Application No. 10/038,630
Paper Dated May 24, 2004
Reply to USPTO Correspondence of February 24, 2004
Attorney Docket No. 3675-010819

AMENDMENTS TO THE DRAWINGS

Fig. 3

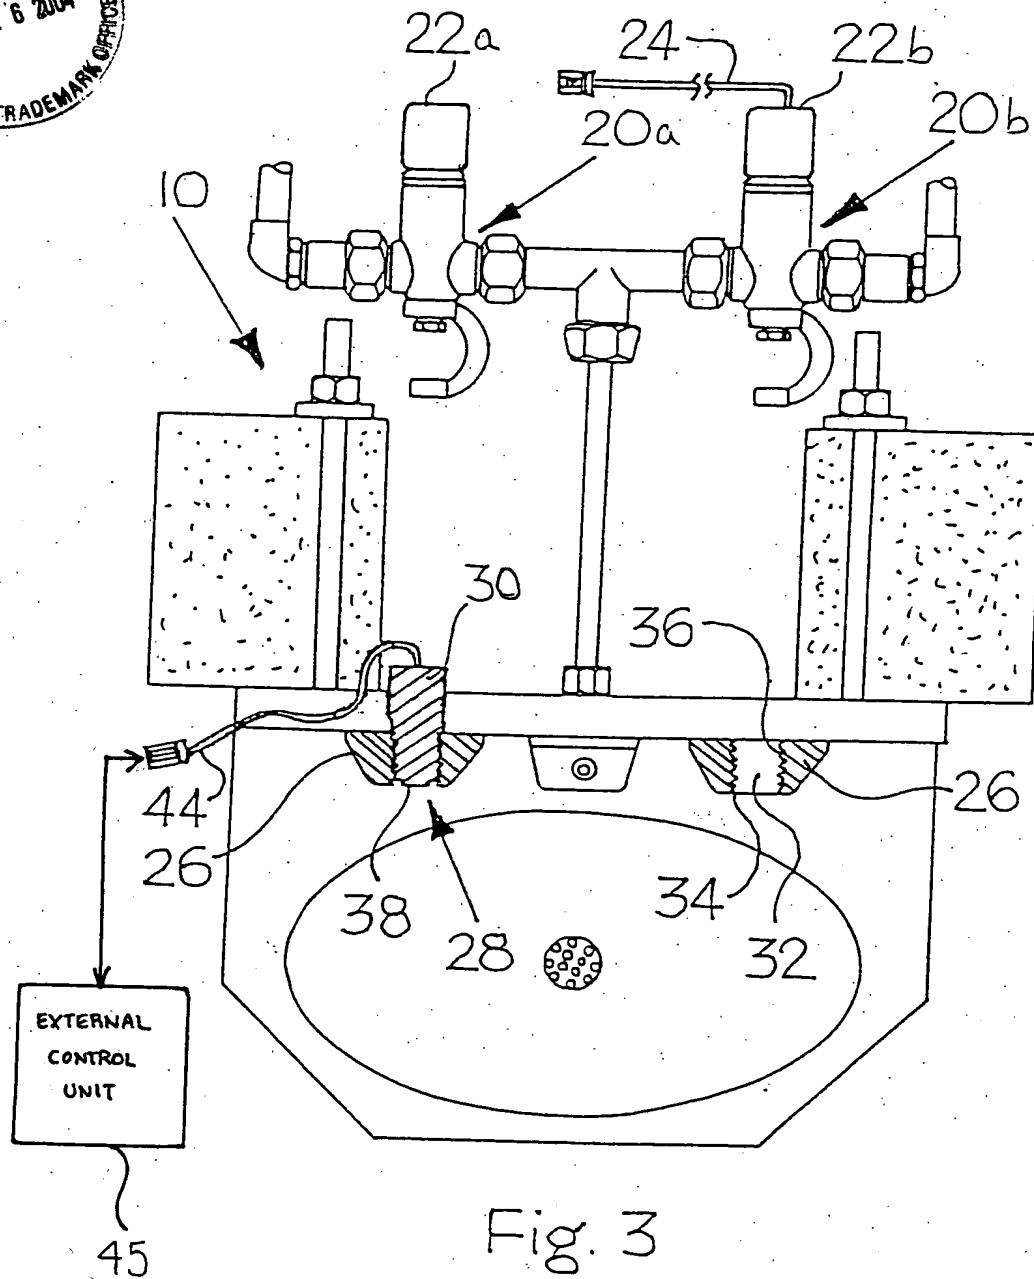
Initially, the Examiner has objected to the drawings under 37 C.F.R. § 1.83(a) as not showing every feature of the invention specified in the claims. Specifically, the Examiner asserts that the "external control unit" must be shown or the feature cancelled from the claims. According to the Examiner's suggestion, Applicant has modified Fig. 3 in order to schematically illustrate the "external control unit" and amended the specification to conform with this drawing modification. No new matter has been added. Applicant respectfully requests withdrawal of this objection.

The attached drawing sheet of Fig. 3 has been corrected to include the “external control unit” in accordance with the Examiner’s requirement. An annotated copy of Fig. 3 is attached showing the correction as well as a Replacement Sheet.
